RIVER TERRACE MEMORY CARE
950 SOUTH END ROAD
MODIFICATION TO CONDITIONAL USE (MD-18-00001) AND VARIANCE (VAR-18-00001)
November 30, 2018

PLANNING COMMISSION RESPONSE COVER LETTER

The following responses have been included to address all remaining items from the planning commission meeting held on November 26, 2018:

RIVER TERRACE MEMORY CARE
TYP. SHARED BEDROOM PLAN

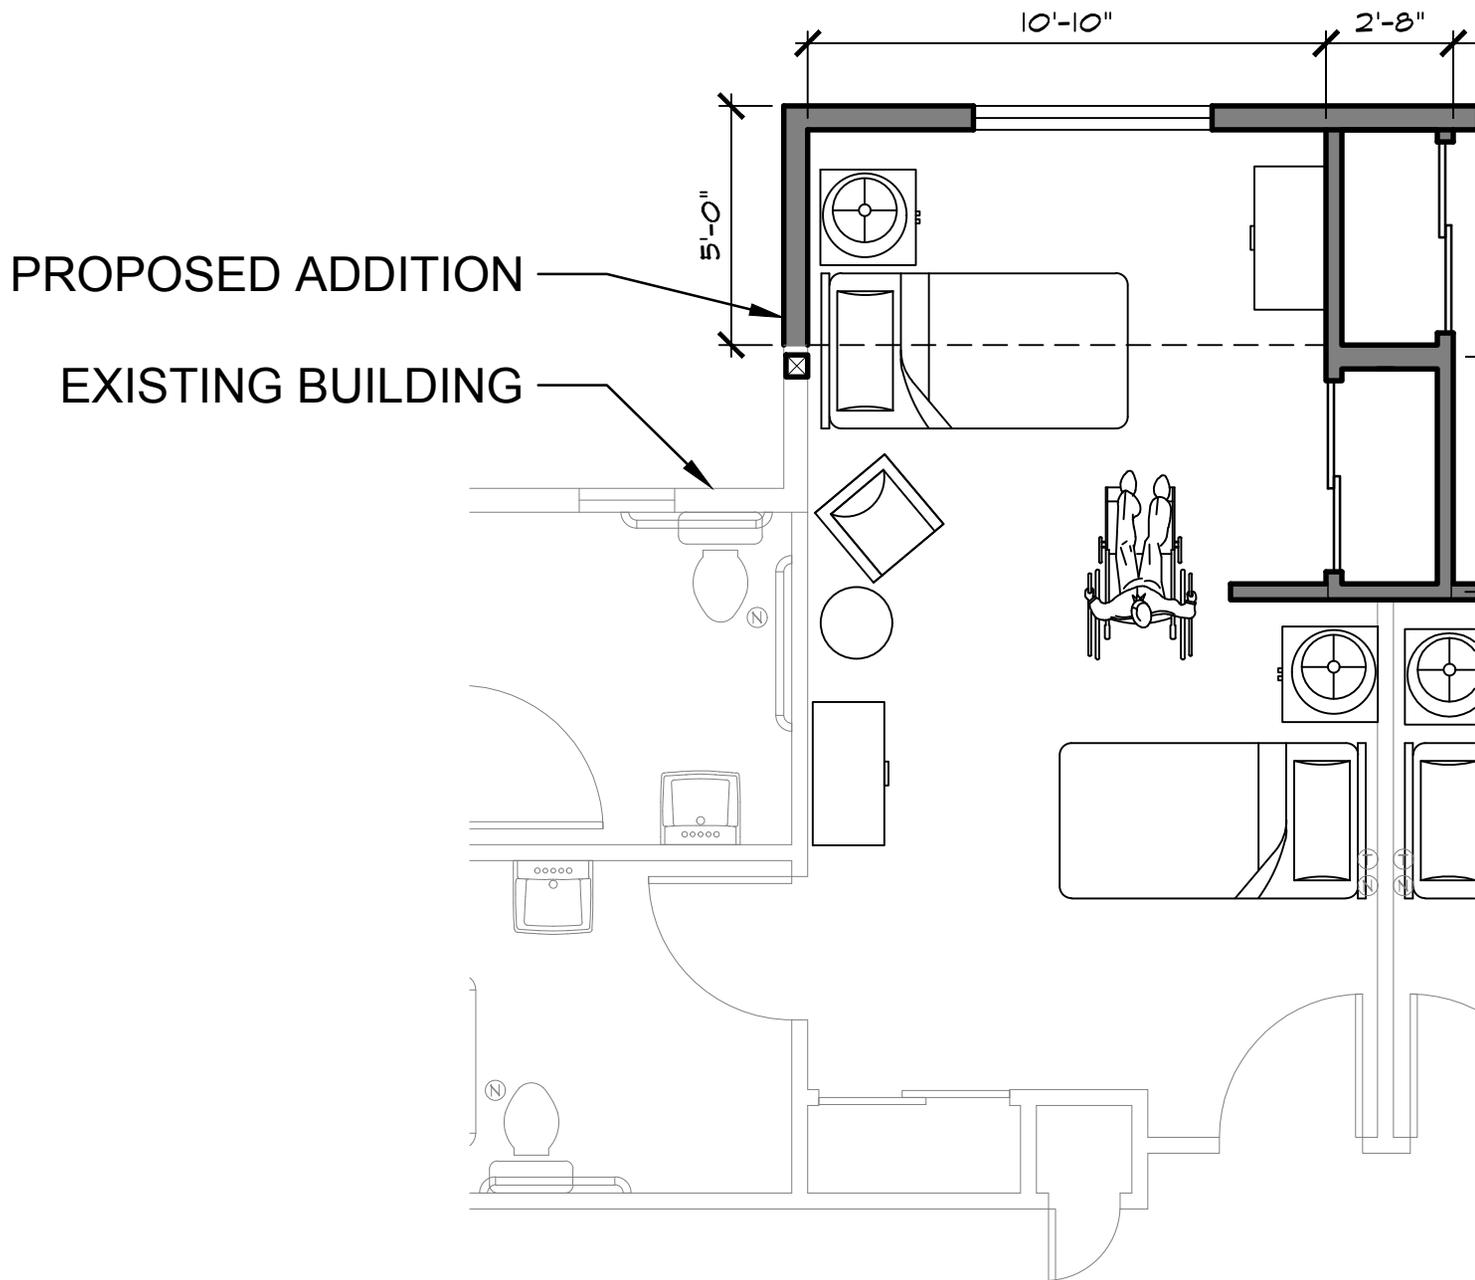
- D. Any impacts resulting from the adjustment are mitigated;

Any impacts to the surrounding buildings are mitigated by maintaining the required zoning setbacks. The building additions are also split into five separate small additions to minimize a large building expansion that could impede the access to desirables or necessities. In addition to this, all existing and new mechanical units are to be relocated and screened away from the property line. A site obscuring fence will also be installed to maintain privacy for the neighbors to the North. The existing South façade is flat along the East portion and could use some modulation to enhance the character of the building. This new South addition also faces Amanda Court and would not impede on the desirables or necessities of the surrounding properties. In addition to this, the surplus of landscaping on the site also mitigates the additional building coverage and minimizes the impact.

RIVER TERRACE MEMORY CARE SOUTH END RD. BLDG. ELEVATION

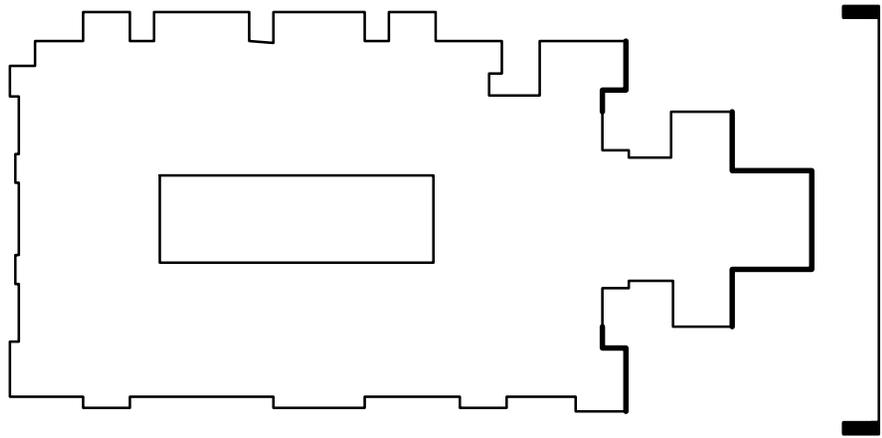
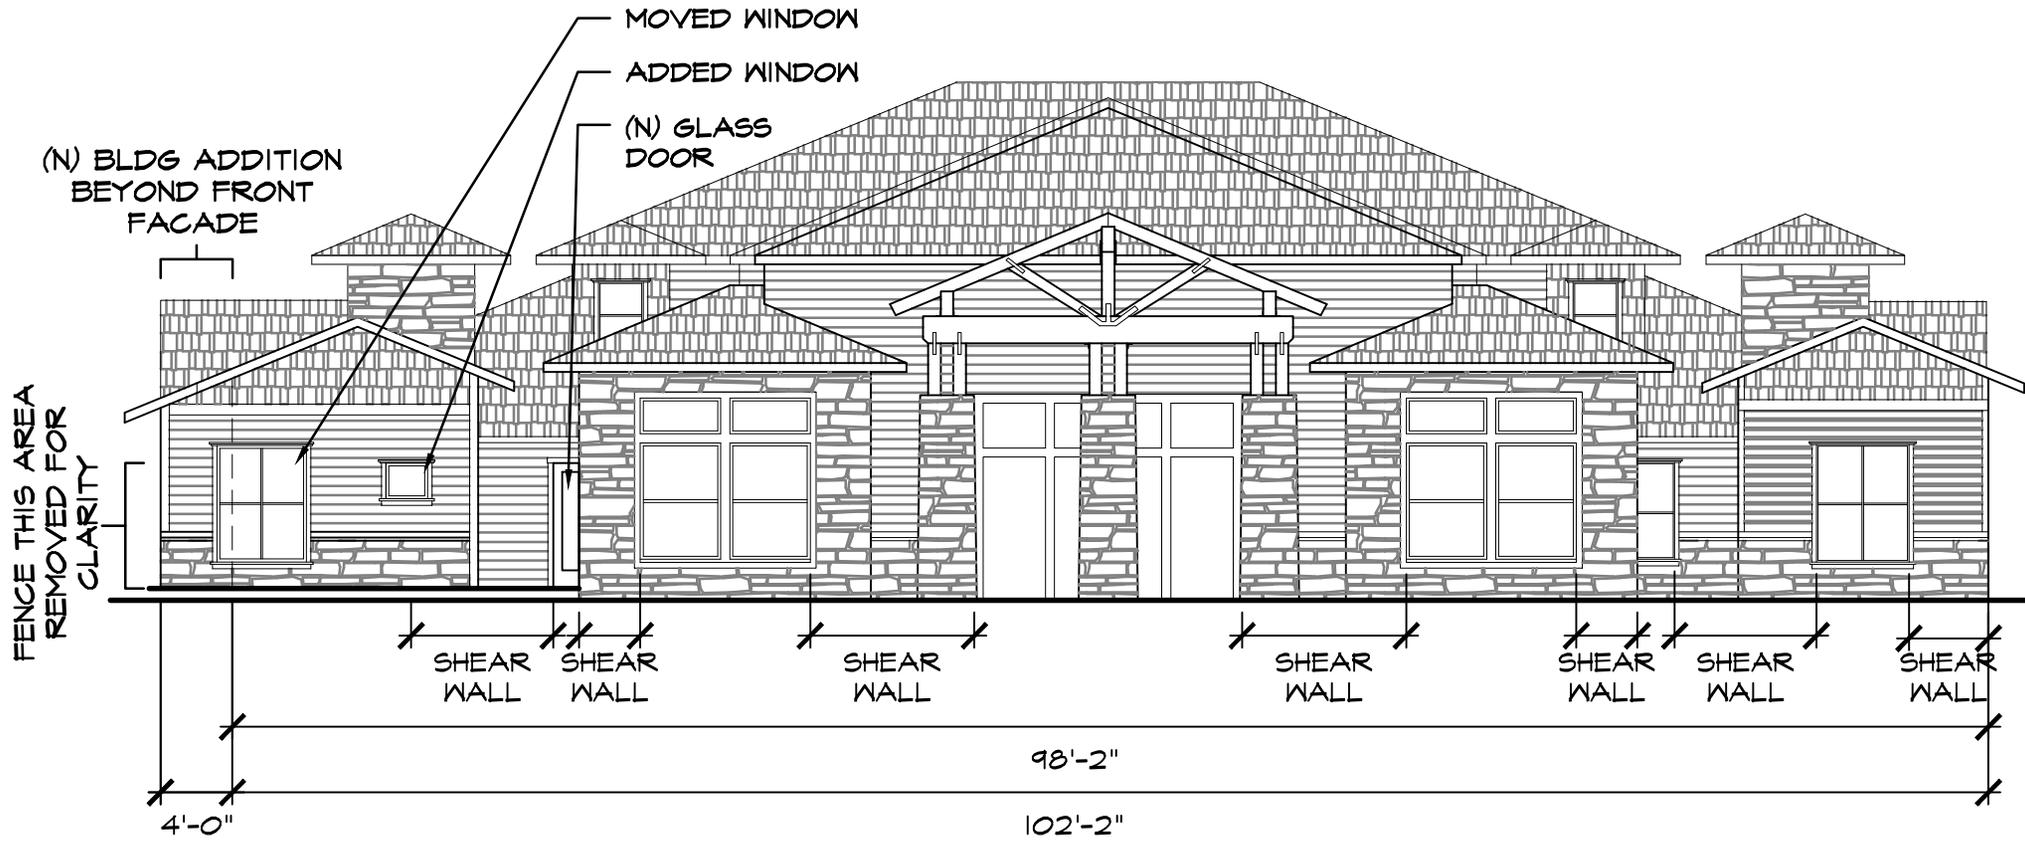
Response to planning commission comments from 11/26/18 meeting:

From what was in our original application and presented to the planning commission on 11/26, the following changes have been made to address transparency:

- The existing window at the SE corner has been added back to the street-facing façade
- A new window has been added at the SE corner to meet the originally proposed percentage of 48% transparency.
- The existing solid door next to the modified portion of the front façade, initially proposed to be a window, has been changed to a full lite glass door.

The length of the South End Road façade originally considered as part of the transparency calculations currently measures about 98'. The originally approved amount of transparency along this façade was thought to be 53% but measures about 47' or 48% on the originally approved elevation. A four foot building addition is proposed at the south end of the front (East) façade and with it an added 2.3 lineal feet of glazing to maintain the originally proposed amount of glazing. With the added glazing, the total percentage of glazing remains unchanged from the originally proposed 48%.

Drainage Area Diagram

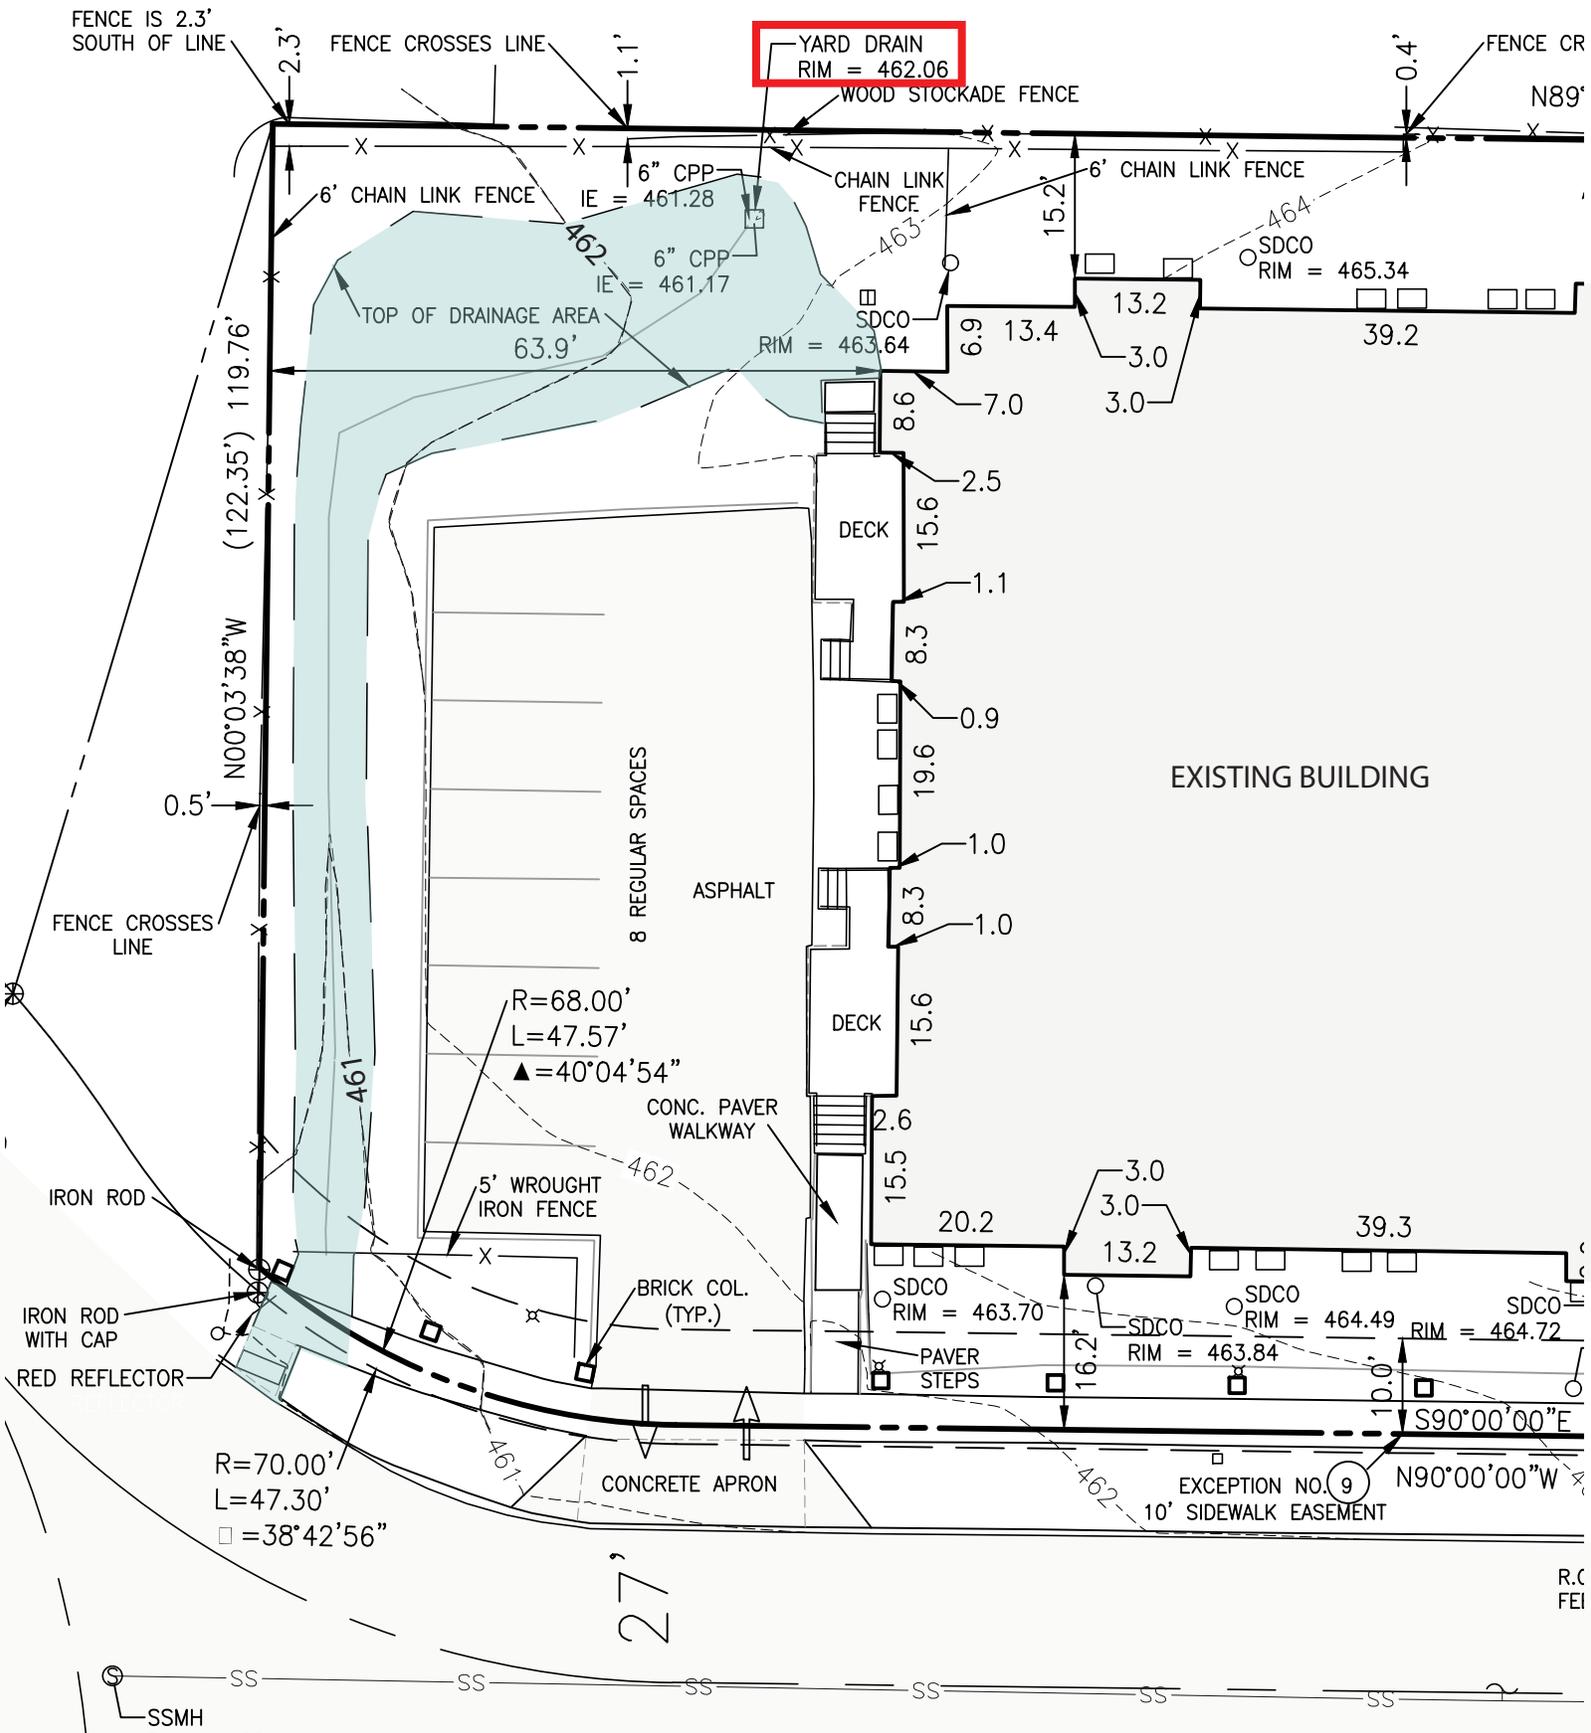
3) Storm Drainage Response

The storm drainage at the property located at 950 South End Road, Oregon City was built, inspected and approved under the original building permit (BB-14-0042). The storm water retention is adequately sized per the calculations provided and approved at the time. The project currently has 38% of the site landscaped, well over the 15% required by the OCMC in an R-10 zone. The total impervious area proposed, including the 529 sq. ft. additional building coverage, is actually less than what the storm drainage was originally designed for. This is because several hundred linear feet of sidewalks in the original design were never built and will not be built with the proposed additions. To speak to the comment made during the first planning commission meeting, the water in the street that was noticed may be the overflow drainage that was designed to flow into the street during surge events.
